Addendum No. 01

Subject: John Taggart ES – Classroom Modernization

SDP Contract Nos. B-047C, B-050C, of 2017/18

This Addendum, dated 9th of May, 2018, shall modify and become part of the Contract Documents for the work of this project. Any items not mentioned herein, or affected by, shall be performed strictly in accordance with the original documents.

DRAWING D1.3 - THIRD FLOOR DEMOLITION PLAN

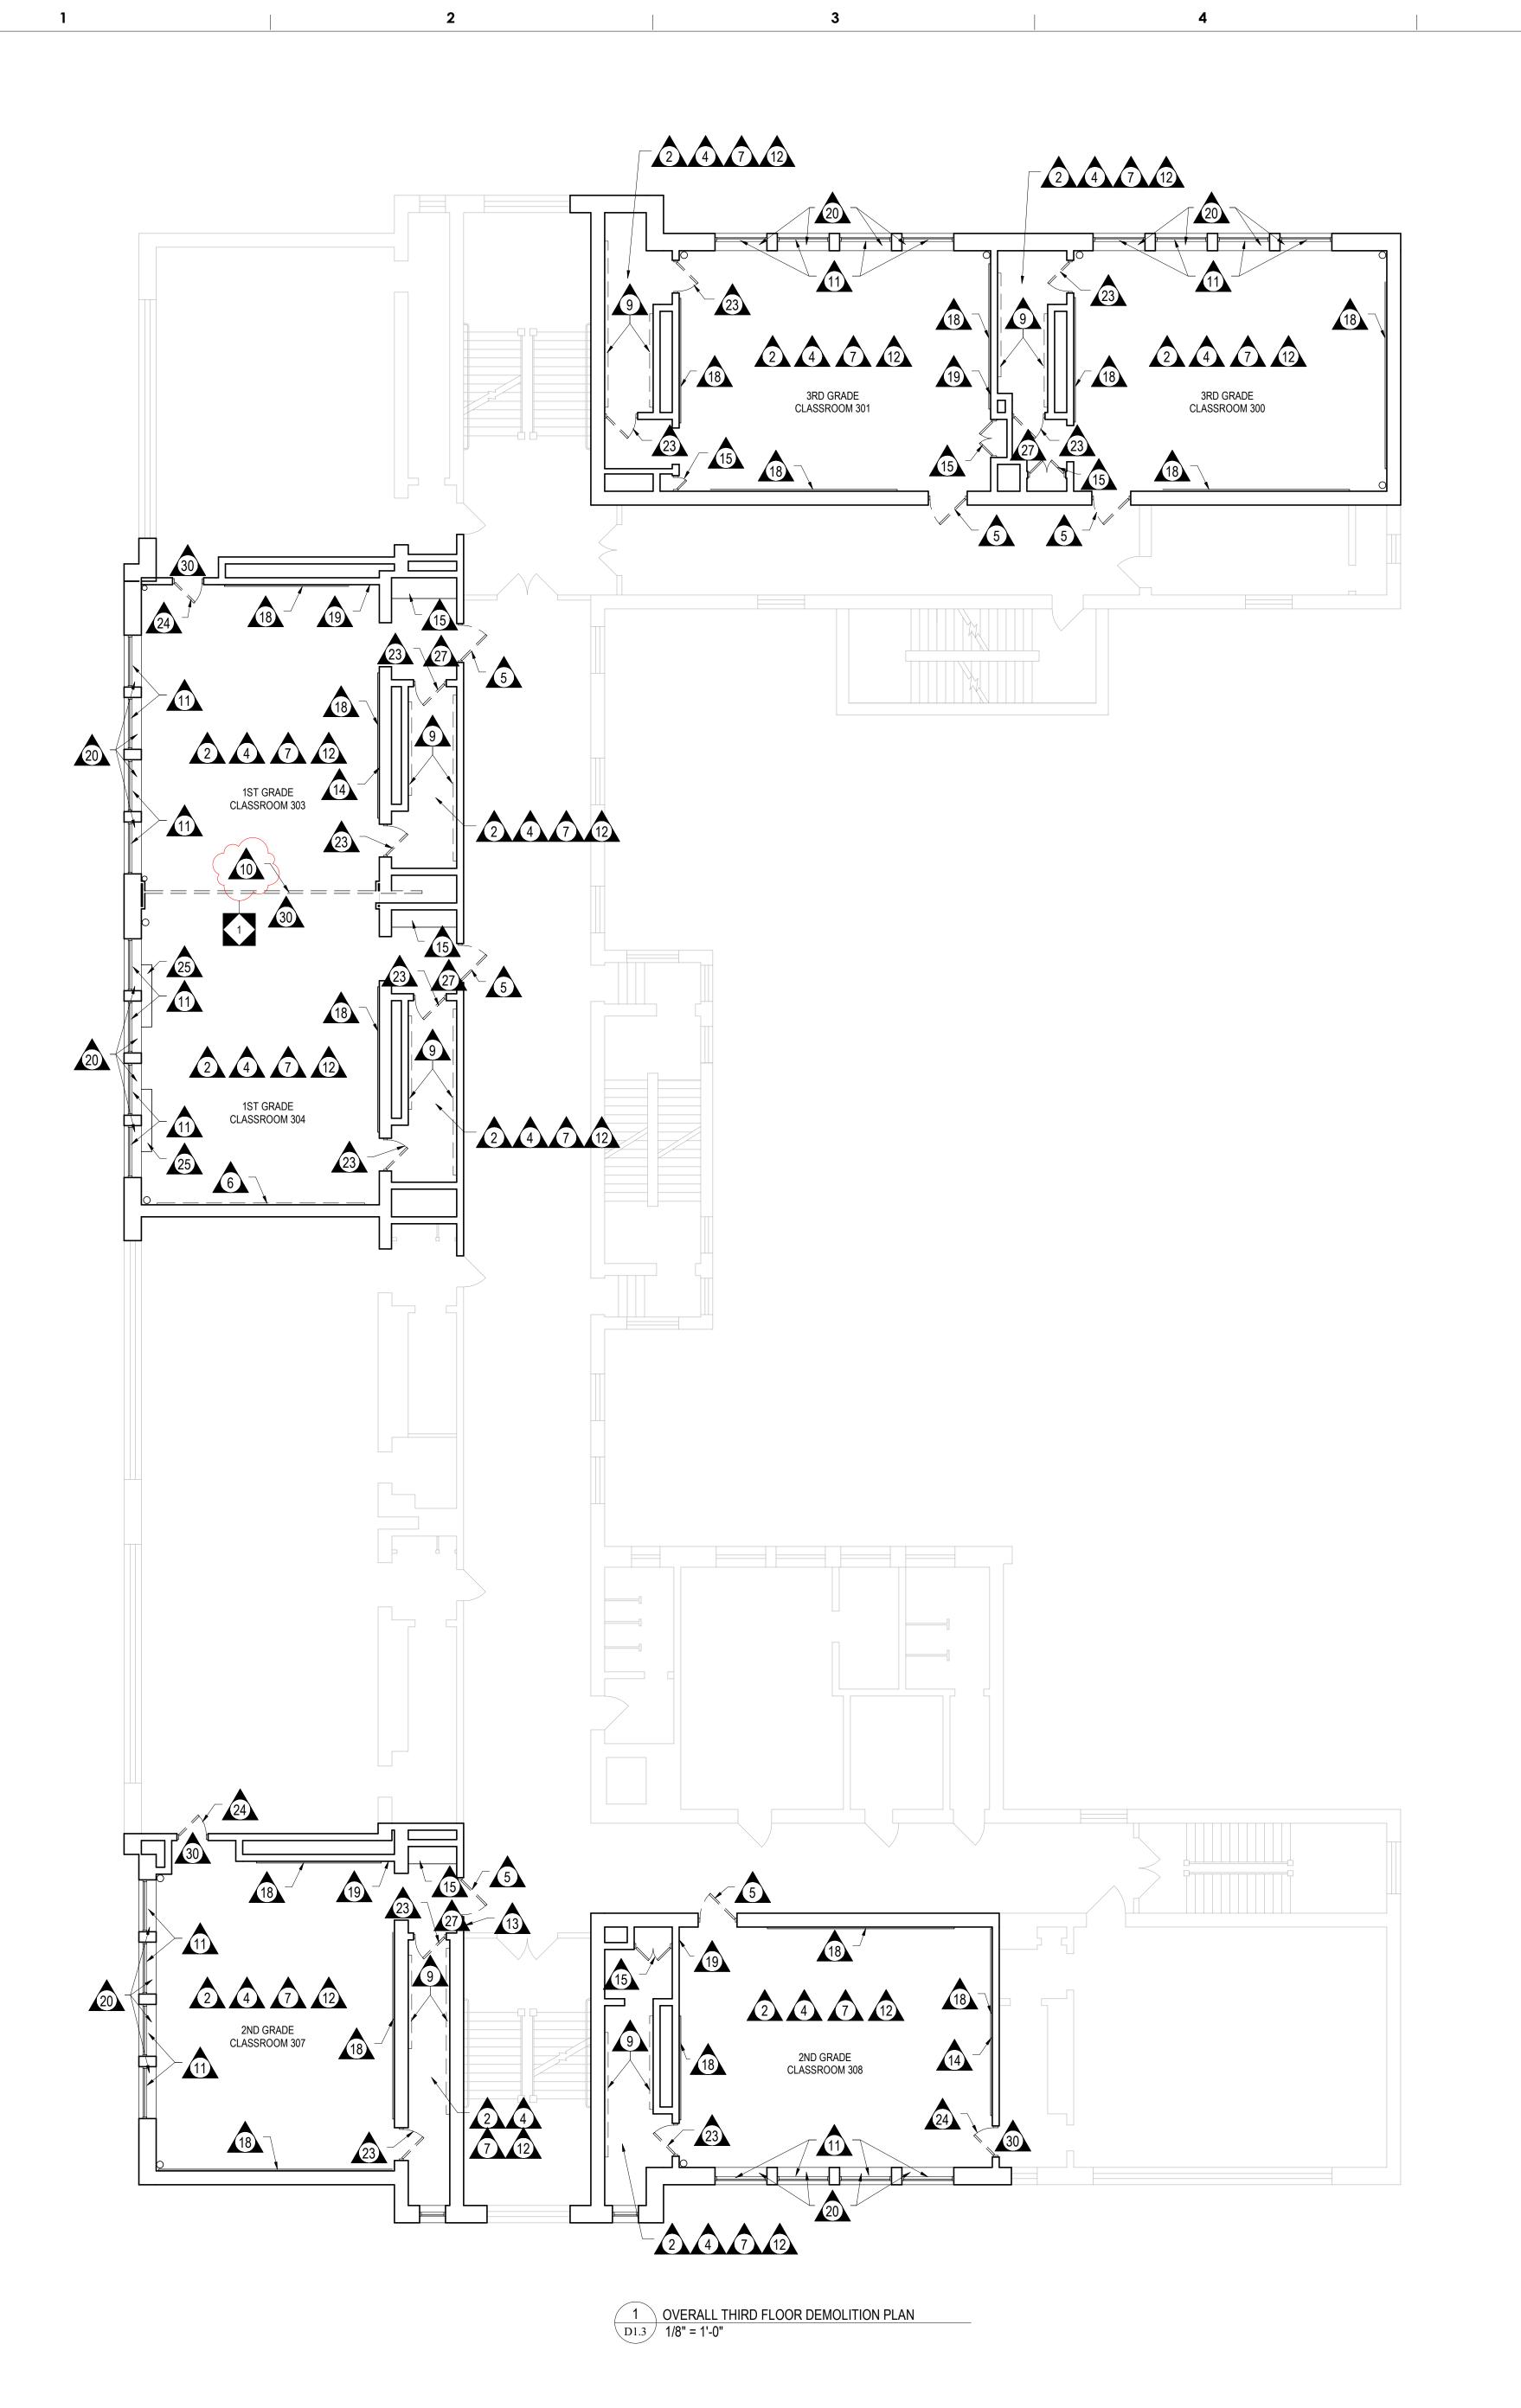
1. **REVISE** demolition note 10.

DRAWING A1.3 - OVERALL THIRD FLOOR PLAN

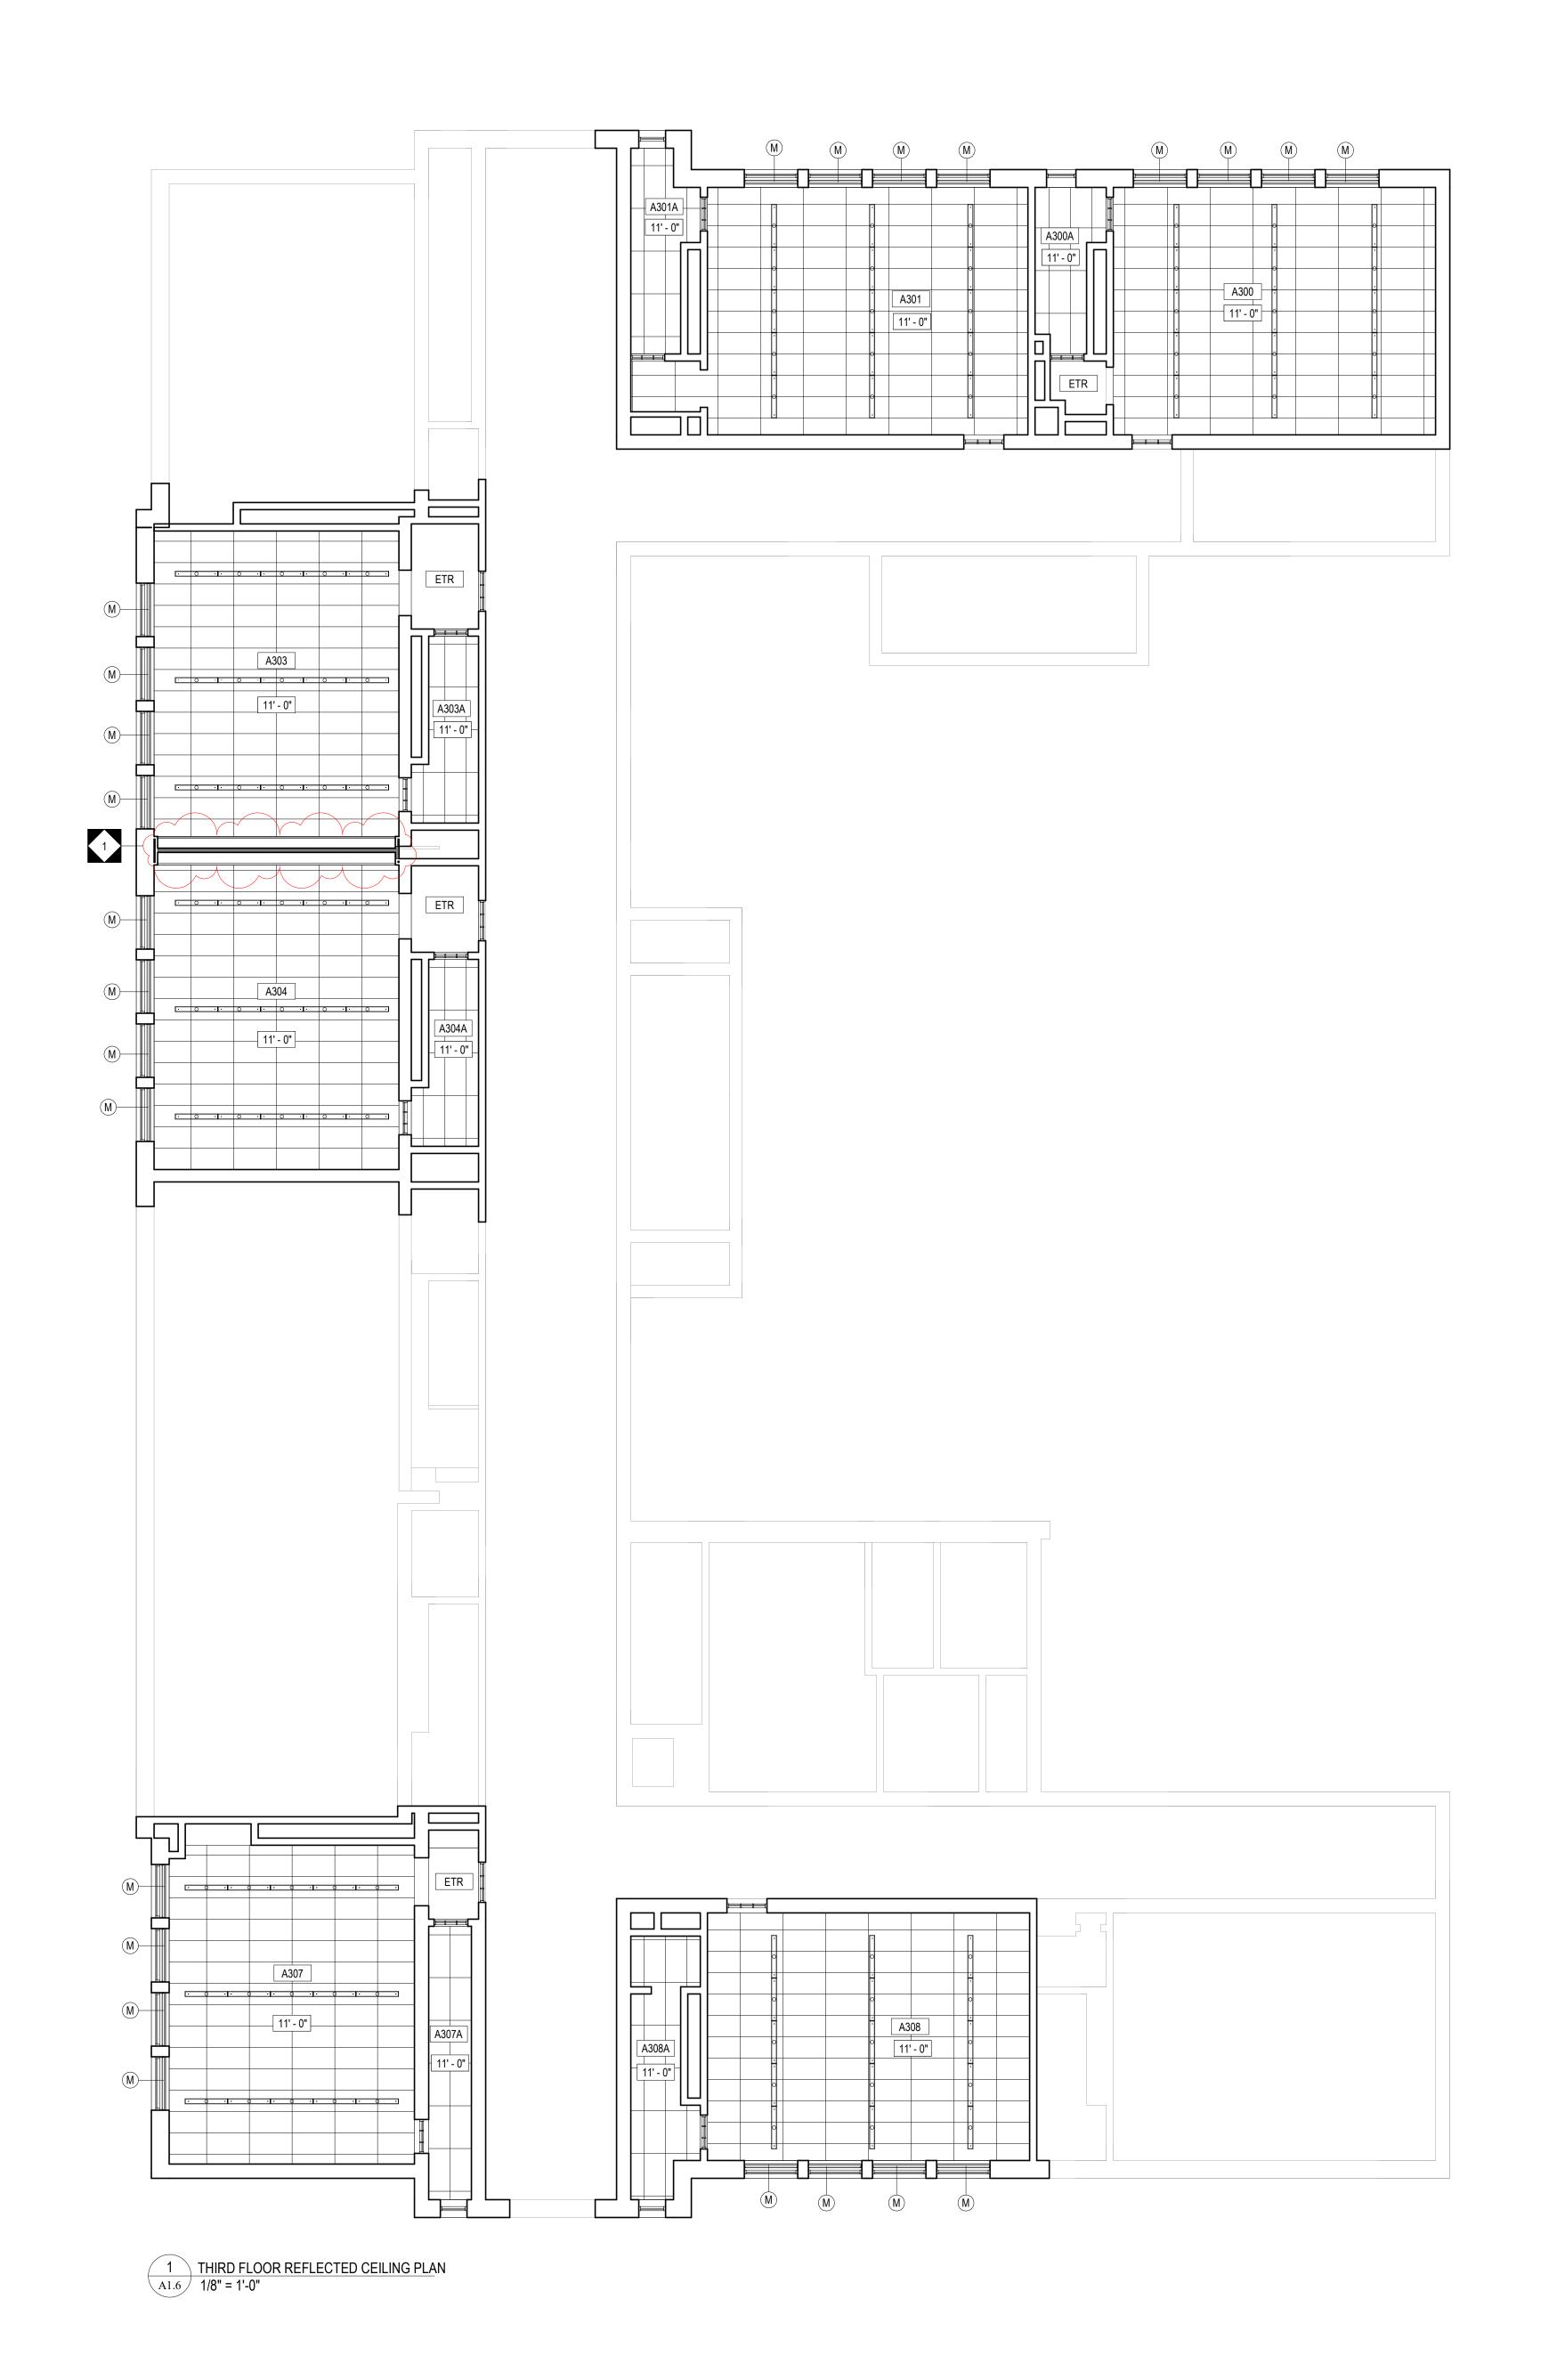
- REVISE existing wood folding wall trim to remain in Classrooms A303 and A304.
- 2. **ADD** bulkhead to box out existing to remain track.

DRAWING A1.6 - THIRD FLOOR REFLECTED CEILING PLAN

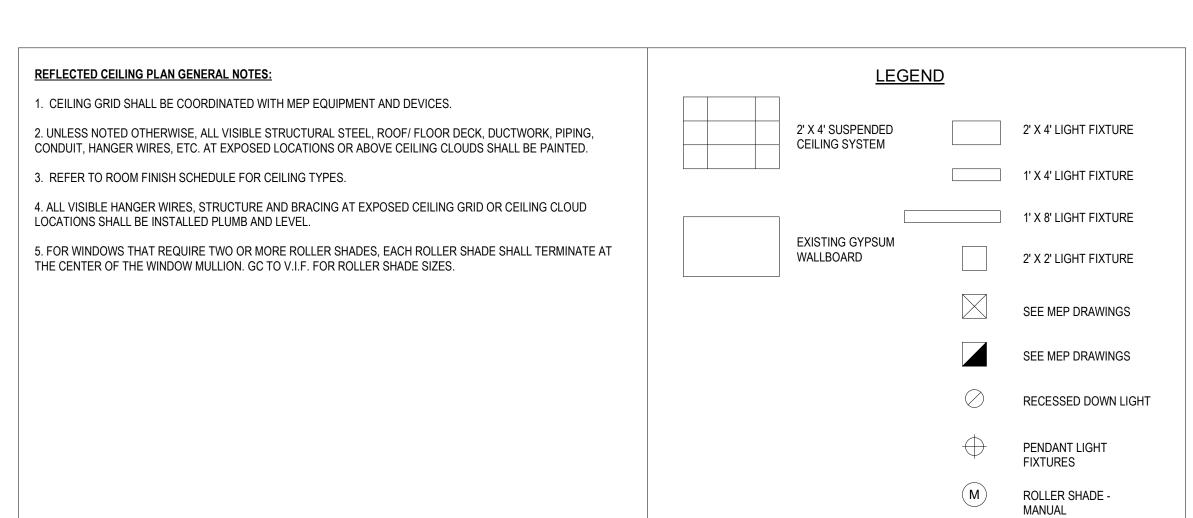
1. REVISE ACT location for existing to remain wood folding wall trim in Classrooms A303 and A304.
